NPL 97-0450

DOCKETS 50-266 AND 50-301  
RESPONSE TO REQUEST FOR ADDITIONAL INFORMATION  
GENERIC LETTER 87-02, VERIFICATION OF SEISMIC ADEQUACY  
OF MECHANICAL AND ELECTRICAL EQUIPMENT IN OPERATING REACTORS  
POINT BEACH NUCLEAR PLANT, UNITS 1 AND 2

**WISCONSIN ELECTRIC**  
**RESPONSE TO REQUEST FOR ADDITIONAL INFORMATION**  
**POINT BEACH NUCLEAR PLANT, UNITS 1 AND 2**  
**UNRESOLVED SAFETY ISSUE A-46 SUMMARY REPORT, DATED MAY 16, 1997**

PBNP - Ground Response Spectrum - 5% Damping

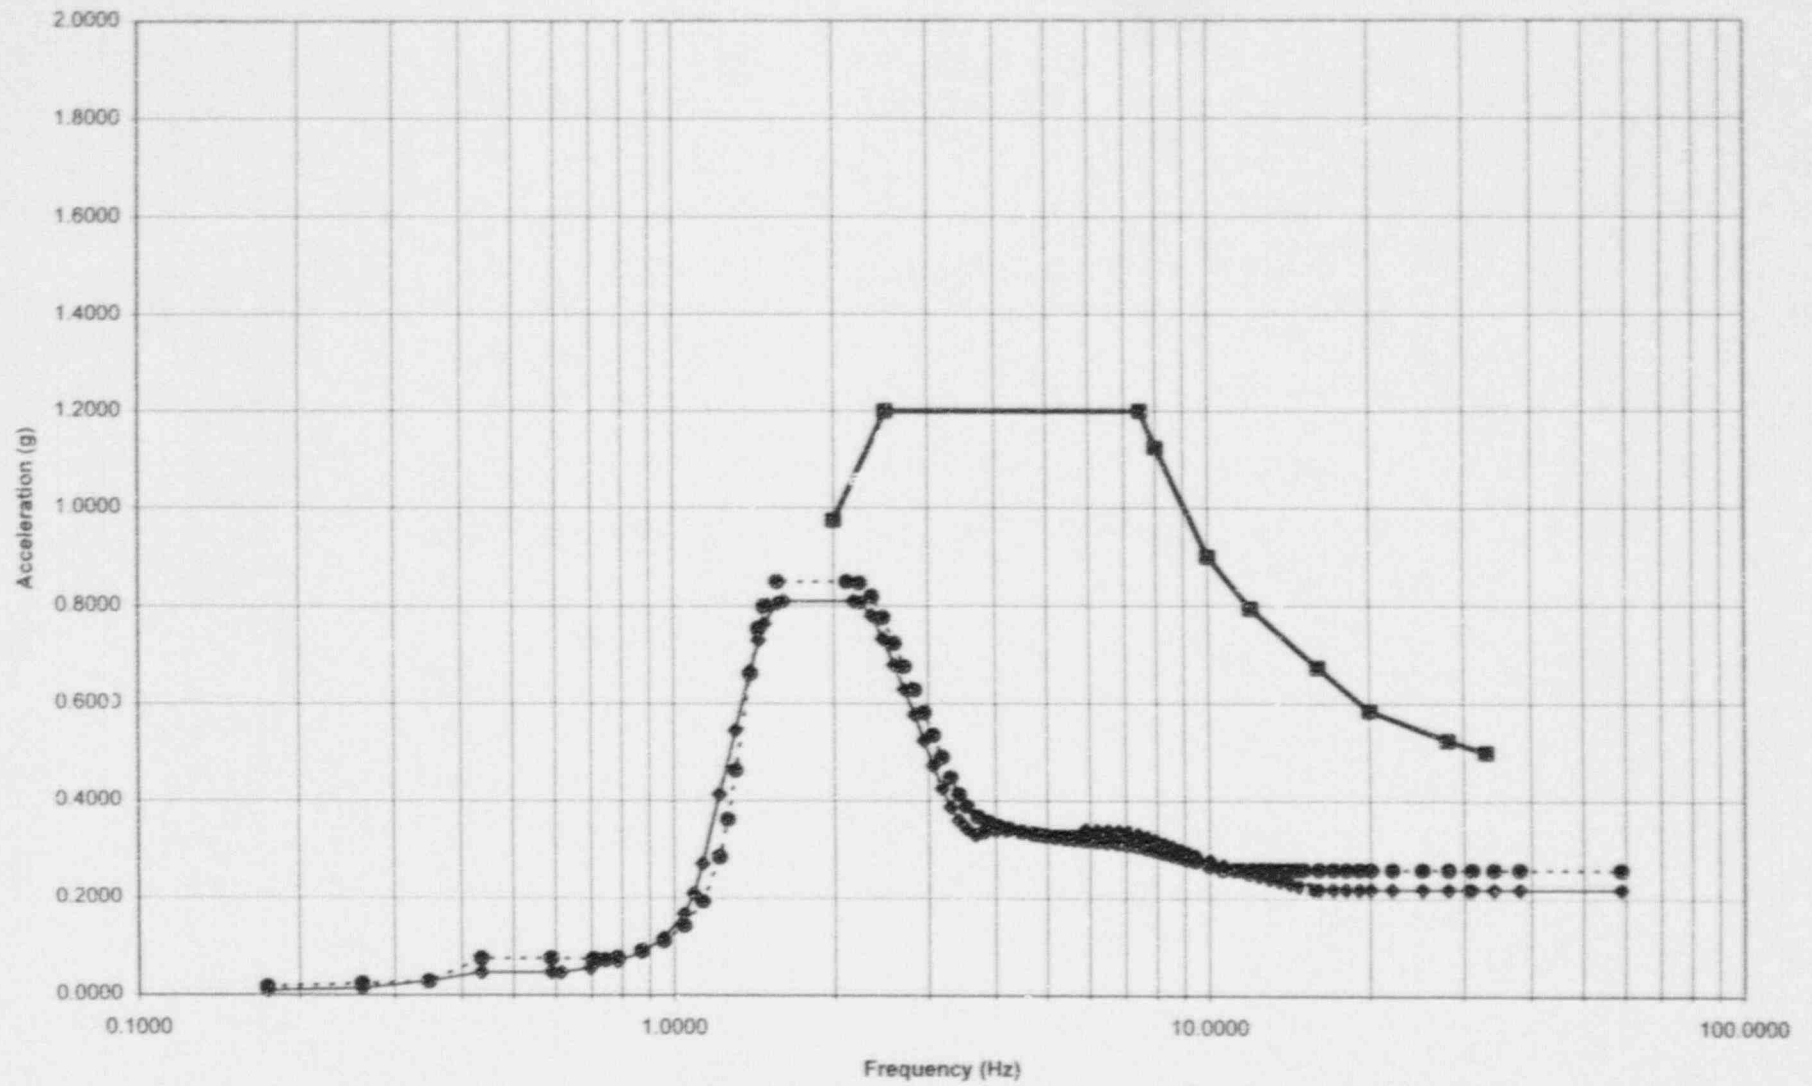
*For the structures identified in Item (a) above, provide the in-structure response spectra designated according to the height about effective grade. If the in-structure response spectra identified in the 120-day-response to Supplement No. 1 to GL 87-02 was not used, provide the response spectra that were actually used to verify the seismic adequacy of equipment within the structures identified in item (a) above. Also, provide a comparison of these spectra to 1.5 times the Bounding Spectrum.*

Method A of Table 4-1 was used because 1SI-866A and 1SI-866B (the Equipment Class 8, Motor-Operated Valves being evaluated) meet the caveats for applying this capacity vs. demand comparison. For PBNP, the Housner Ground Response Spectrum (GRS), anchored at 0.12g is defined at the free field ground surface. The PBNP 5% damped Housner GRS Safe Shutdown Earthquake (SSE) is bounded by the GIP Bounding Spectrum as shown in Enclosure 1, and the valves are located on the 8' elevation which is < 40' above effective grade. Therefore, it is directly applicable for comparison with the Bounding Spectrum (Reference 9, page 100).

Enclosure 1 provides the plot of the 5% damped horizontal Housner Ground Response Spectra (GRS) plotted in comparison to the GIP Bounding Spectrum and the plots of the 5% damped horizontal ISRS for all of the structures at PBNP for those elevations within 40 feet of effective grade plotted in comparison to the GIP Reference Spectrum (1.5 x Bounding Spectrum).

PBNP - Control Building In-Structure Response Spectrum - 5% Damping

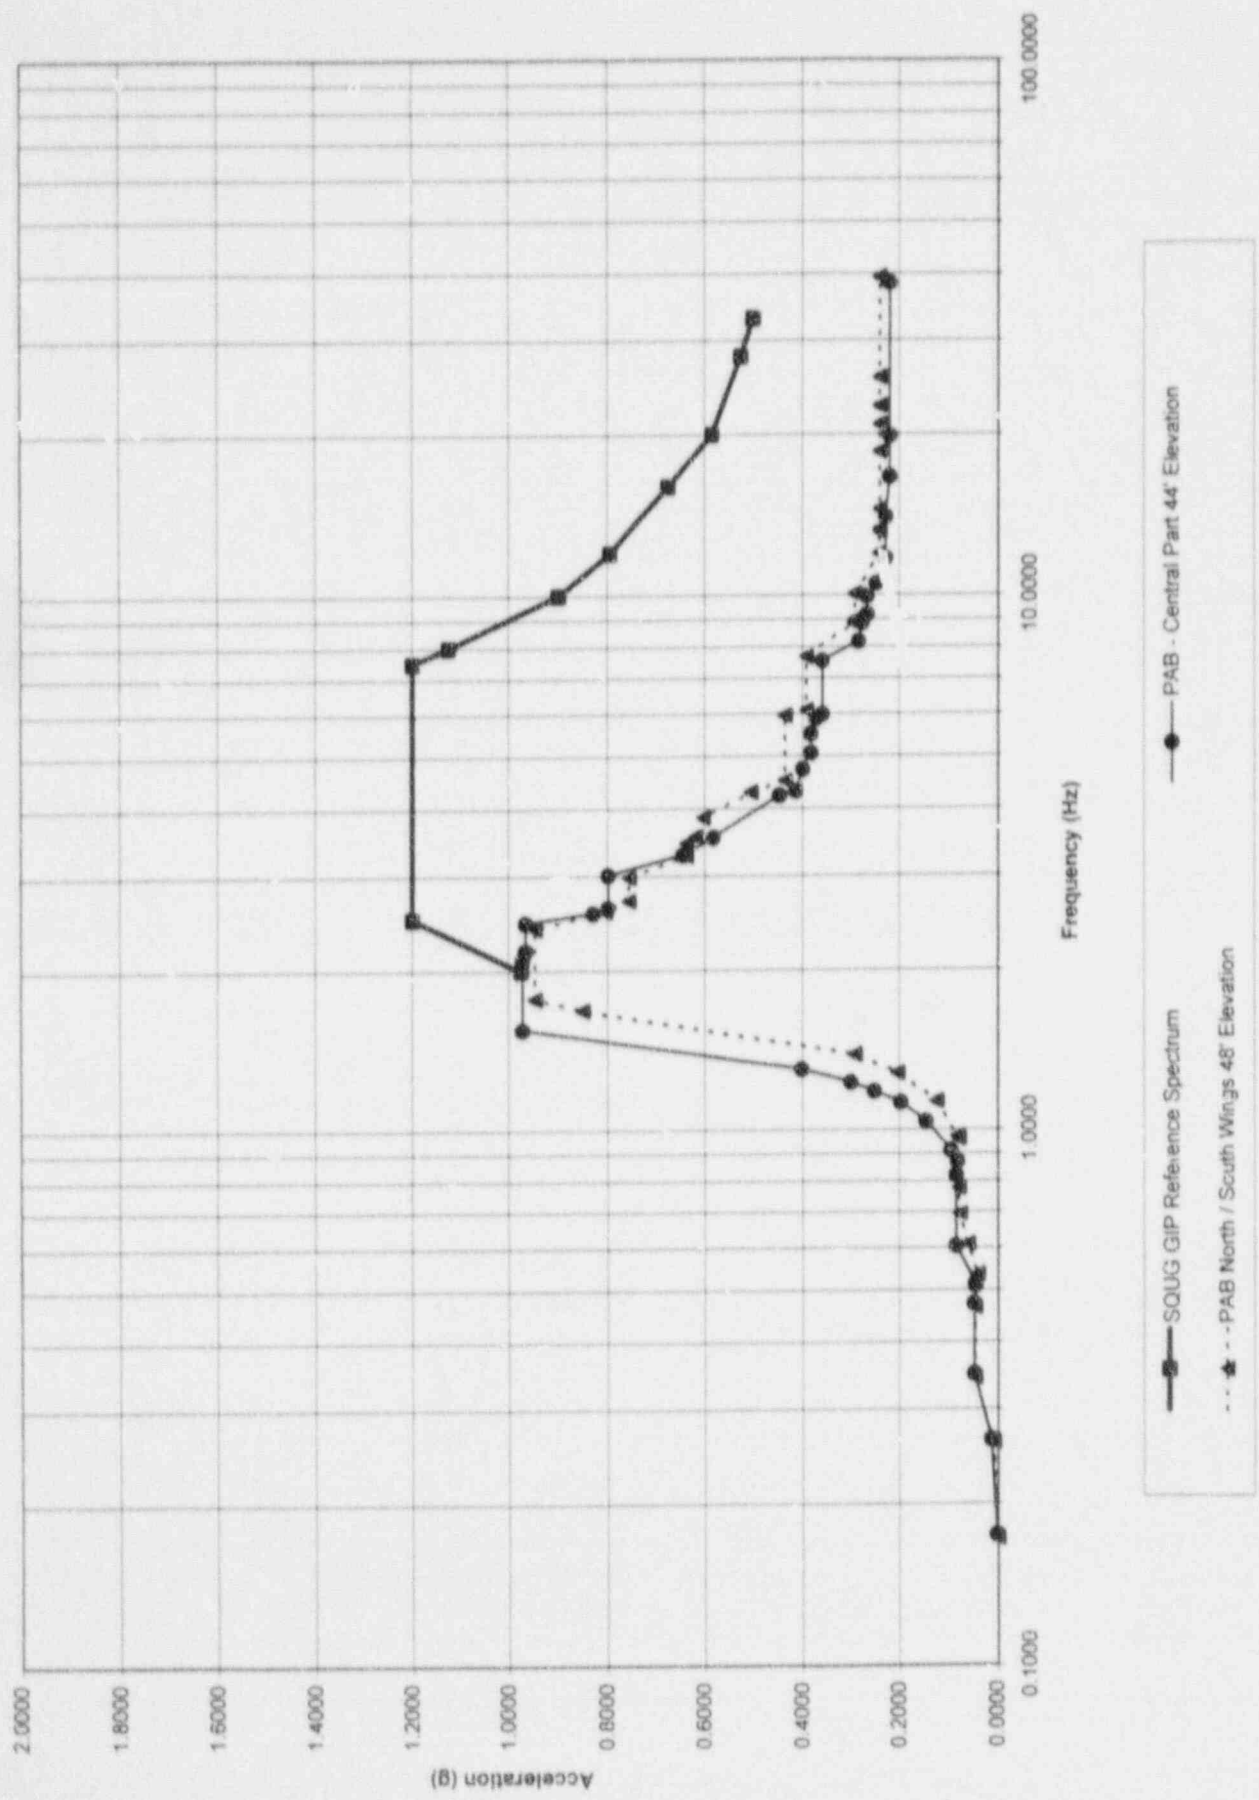
*Identify structure(s) that have in-structure response spectra (5 percent of critical damping) for elevations within 40-feet above the effective grade, which are higher in amplitude than 1.5 times the Seismic Qualification Utility Group (SQUG) Bounding Spectrum.*

The effective grade for all structures at Point Beach Nuclear Plant (PBNP) is established at 8'. The following table lists those structures for which the 5% damped horizontal ISRS, for elevations within 40' above the effective grade, are higher in amplitude than 1.5 times the Generic Implementation Procedure, Revision 2 (GIP-2) (reference 1) Bounding Spectrum.

The horizontal in-structure response spectra for the Control Building, 44' elevation, 5% damping is provided as one of the ISRS in Enclosure 1. It is plotted on the same graph with the Control Building 26' elevation, 5% damping and is plotted in comparison to the GIP-2 Reference Spectrum.

**LAR 003 - Five Tier Unbraced Cantilever Hanger**

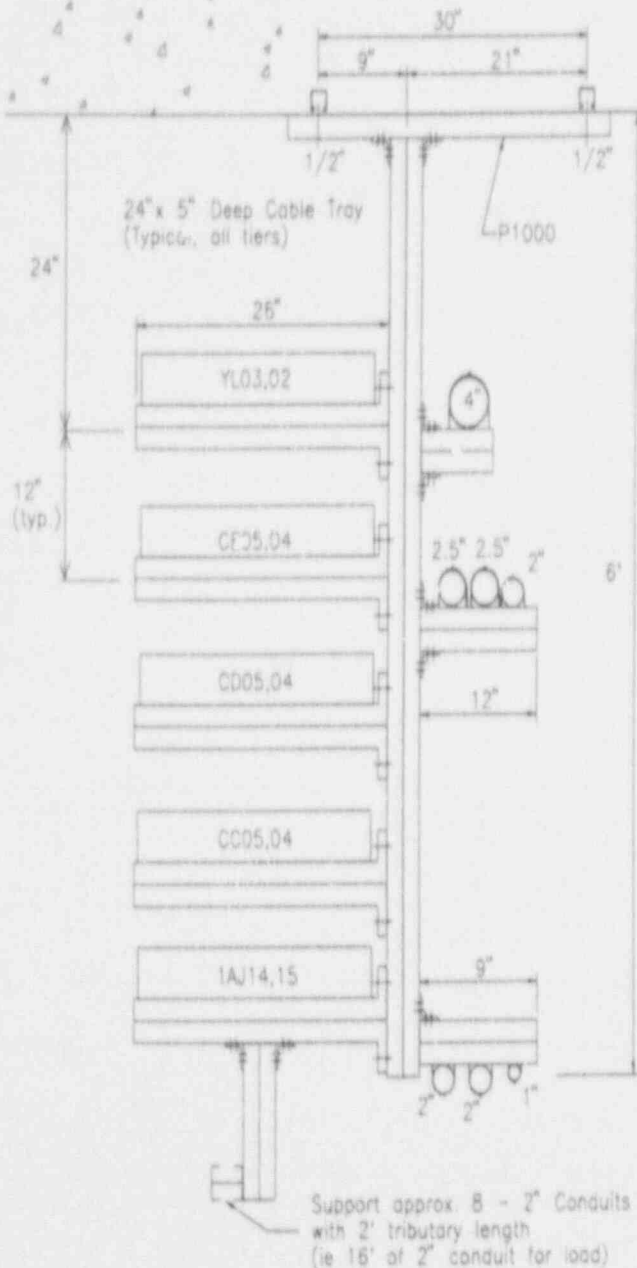
*For the interior of the cable spreading room, provide drawings of cable trays, structural drawings of the floor and/or the ceiling at the elevation where the cable trays are attached, floor response spectra (discuss how the flexibility of the floor was taken into consideration) and final results of cable tray evaluation in terms of deflection due to the system stress level. Provide stiffness (natural frequencies) of the cable tray systems and supporting floor and/or ceiling including weight of the cable tray and its contents such as fire retardant. Provide the margins to the design limits and/or failure. In addition, provide validation documents of any computer codes used to produce the results discussed above.*

Four Limited Analytical Review (LAR) cable tray supports were selected in the CSR, LAR 3, 4, 5, and 10. The PASS form provides the plan view sketches of these four LARs. The LAR analysis is contained in Stevenson & Associates (S&A) calculation 91C2696-C-018 (Reference 16) and was submitted as Enclosure 5 to Reference 3. The analysis for the CSR LARs is contained on the following pages:

The margins to the acceptance criteria for the LAR analyses are provide in Section 7.5.1, Summary of Results, of the Wisconsin Electric Seismic Evaluation Report, Revision 1 (References 6 & 7). Table 7-2, Critical Interaction Values, provides the resultant critical interaction value(CIV) for each LAR analysis. A CIV > 1 indicates that the cable tray support has exceeded the allowable load limits.
